Remarks

Tyco 18005 (AT 20958-38)  
PATENT

S/N: 10/789,856 DOCKET: 18005 (AT: 20958-38)

FIG. 1

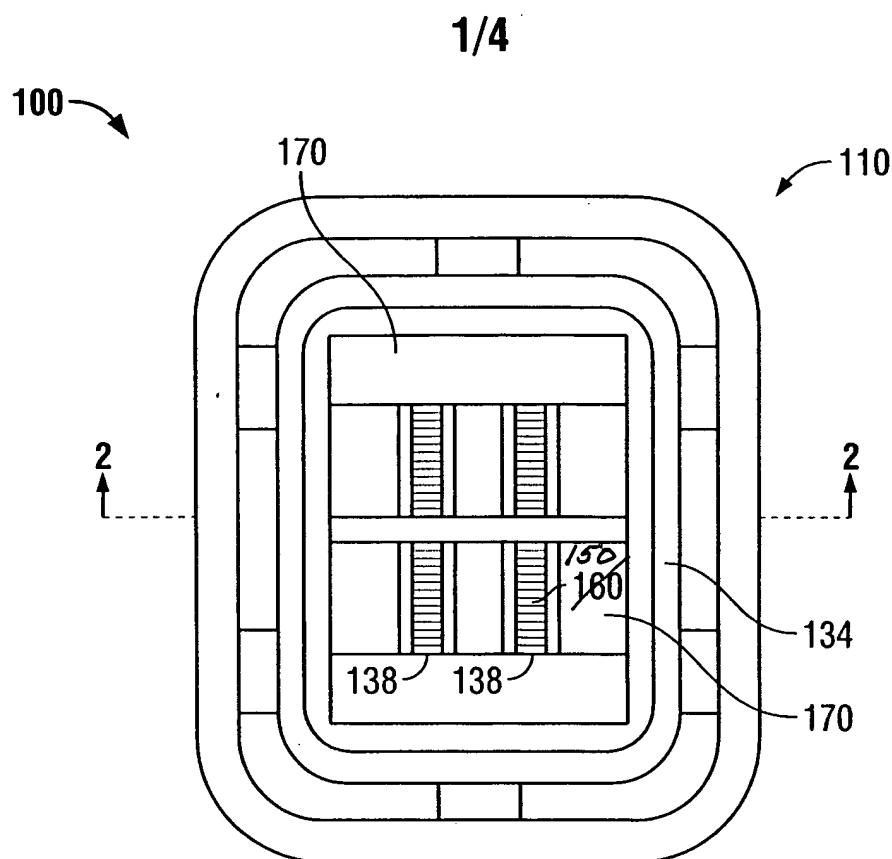
The objections to the drawings are respectfully traversed. Submitted herewith are replacement drawing sheets incorporating changes to Figures 1, 2 4, 5, and 6 as indicated above. In Figure 1, the reference numeral 160, which was not referenced in the description, is corrected to 150. In Figures 2, 4, 5, and 6, the cross hatching is changed for clarity, adopting the Examiner's suggestions. No new matter has been added.

The attached replacement sheets of drawings includes changes to Figures 1, 2, 4, 5, and 6. Replacement sheet 1 replaces original sheet 1 including changes to Figures 1 and 2. In Figure 1, reference numeral 160 is corrected to 150. In Figure 2, the cross hatching is expanded for clarity. In addition, the cross hatching for seal members 134, and 146 is changed for clarity as suggested by the Examiner.

FIG. 2

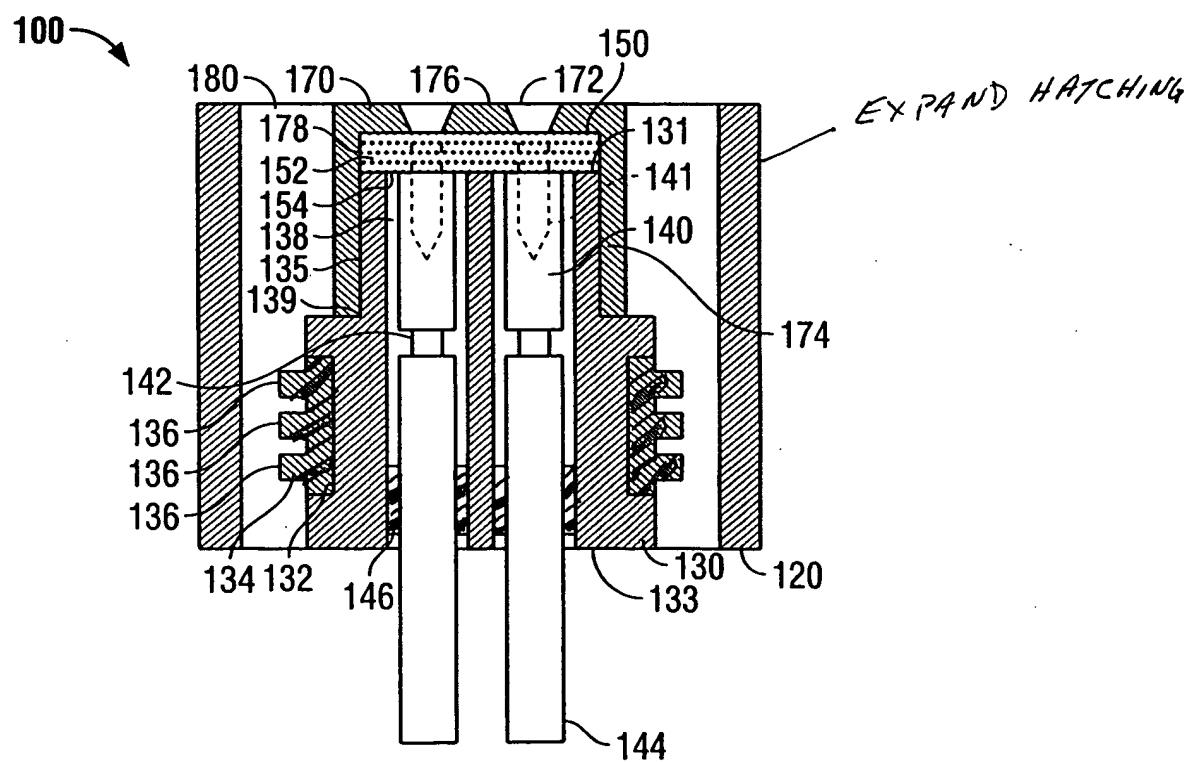
Applicant notes that, with respect to Figures 2, 5, and 6, the gel material (150) has sufficient structural integrity, that the gel material does not flow into the chambers (138) as discussed in paragraph 0016 in the description. Similarly, the gel material does not flow into the beveled areas (172). These areas therefore are not changed in the drawings.

FIG. 4

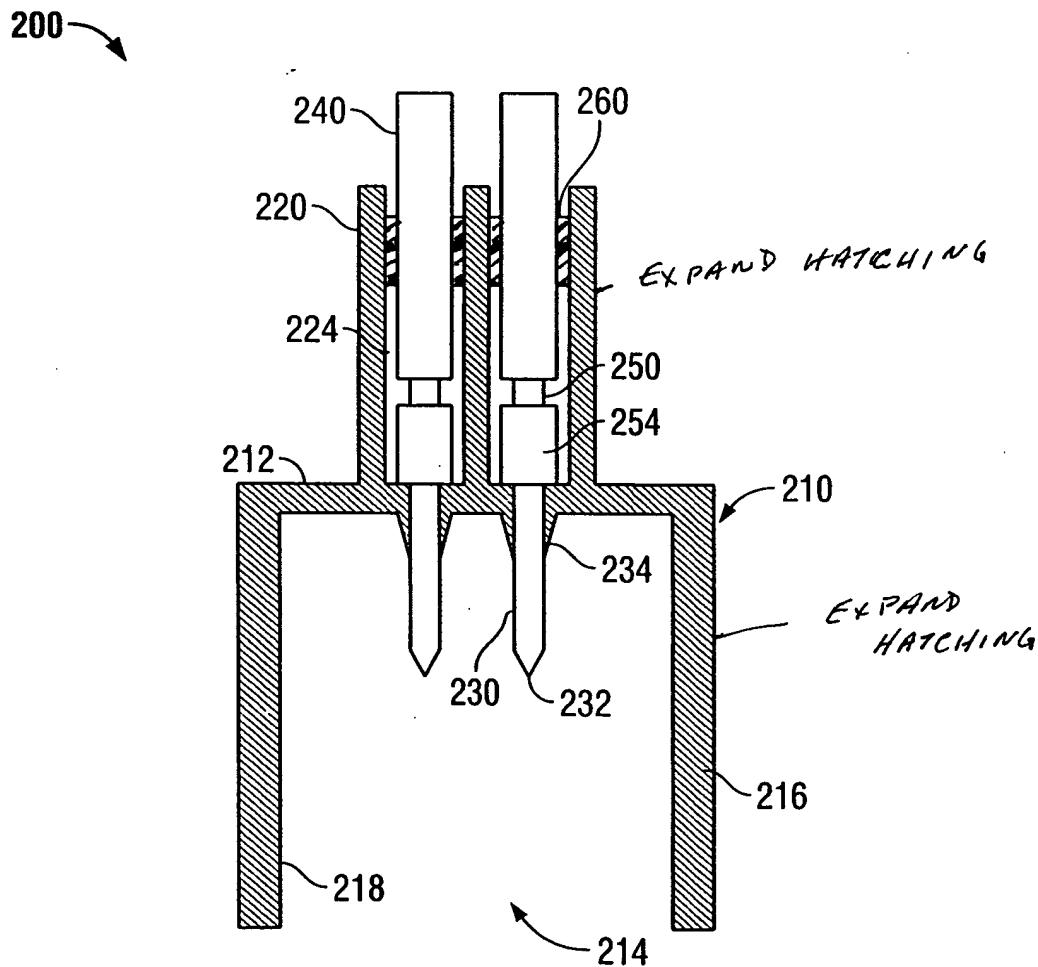
Replacement sheet 2 replaces original sheet 2 including changes to Figure 4. In Figure 4, the cross hatching is expanded for clarity. In addition, the cross hatching for seal members 260, is changed for clarity as suggested by the Examiner.

FIG. 5

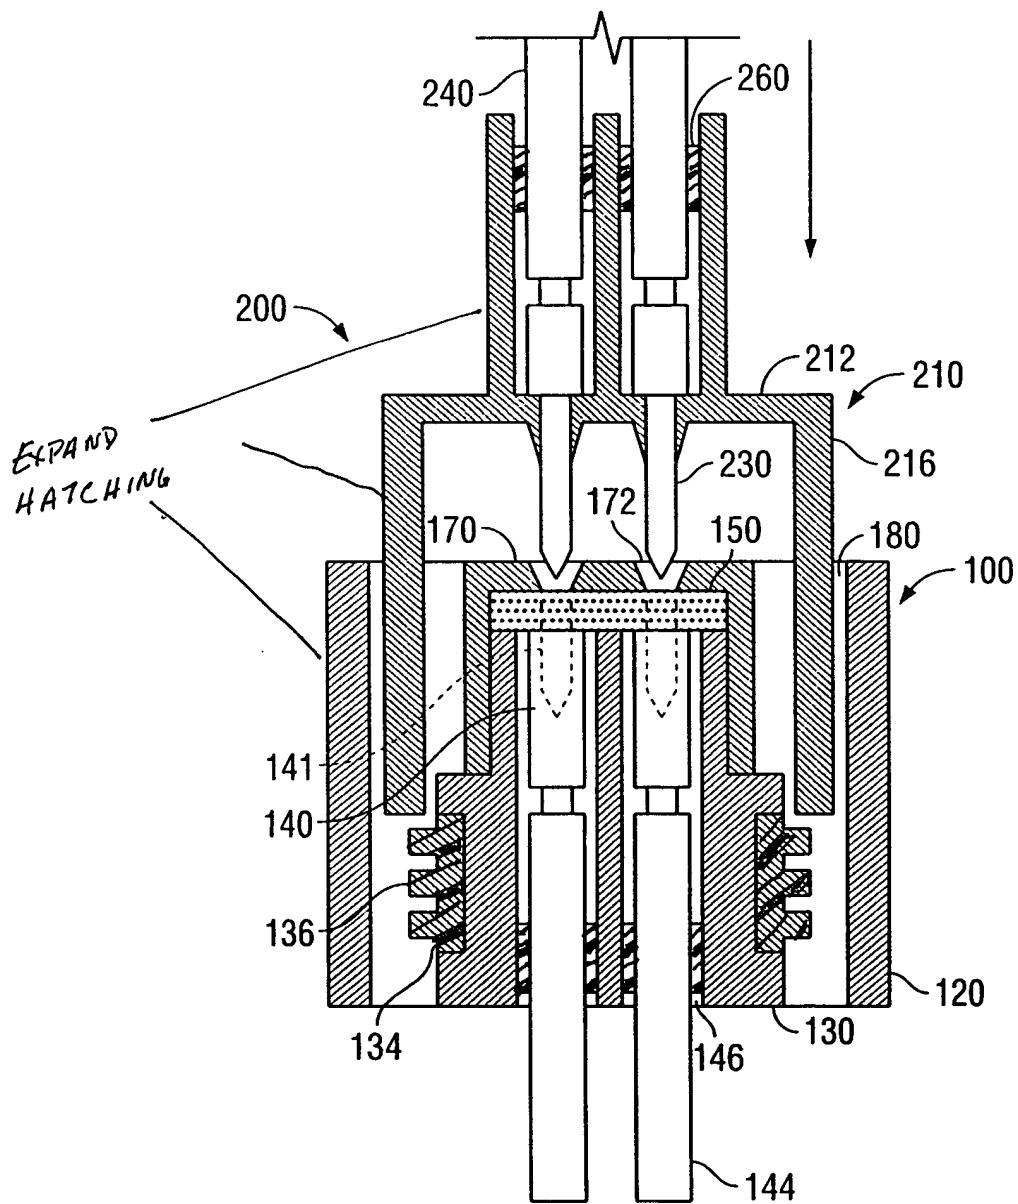
Replacement sheet 3 replaces original sheet 3 including changes to Figure 5. In Figure 5, the cross hatching is expanded for clarity. In addition, the cross hatching for seal members 134, 146, and 260 is changed for clarity as suggested by the Examiner.

FIG. 6

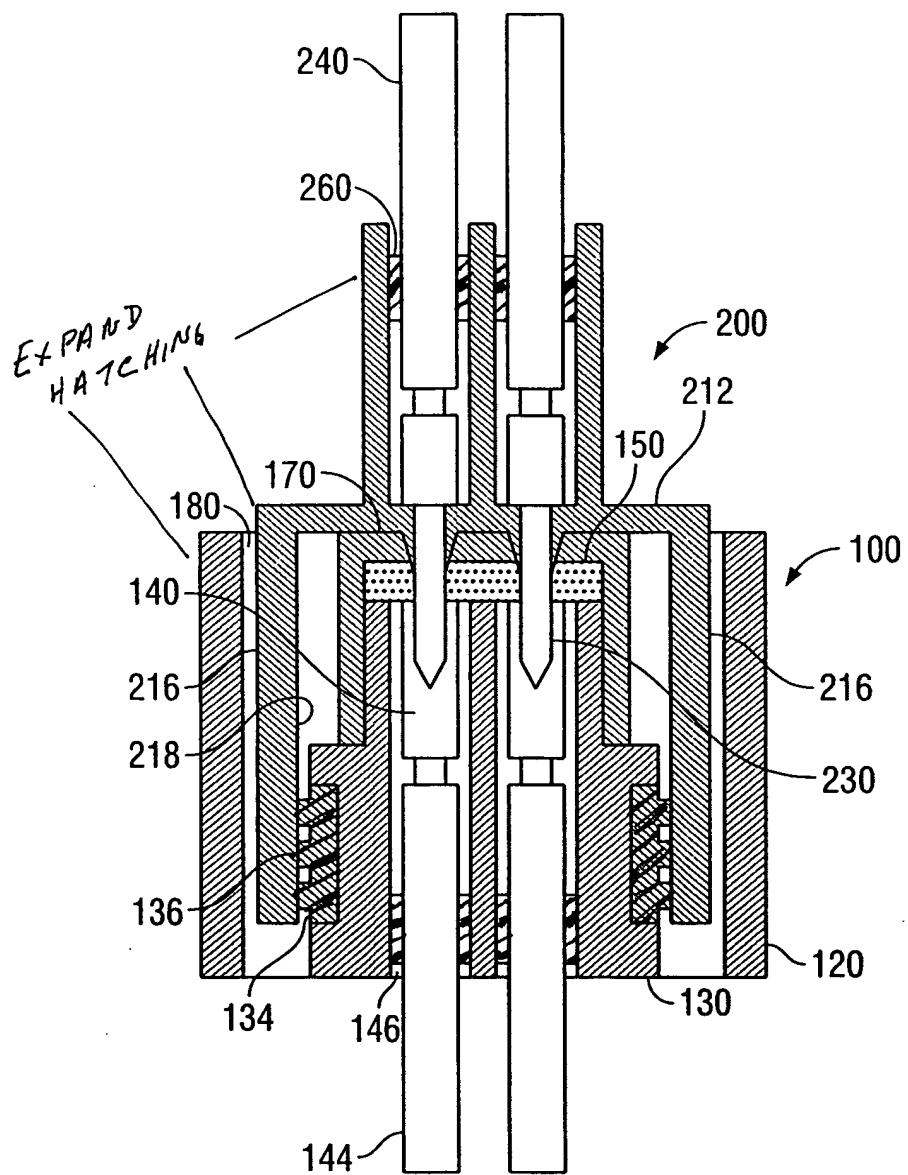
Replacement sheet 4 replaces original sheet 4 including changes to Figure 6. In Figure 6, the cross hatching is expanded for clarity. In addition, the cross hatching for seal members 134, 146, and 260 is changed for clarity as suggested by the Examiner.
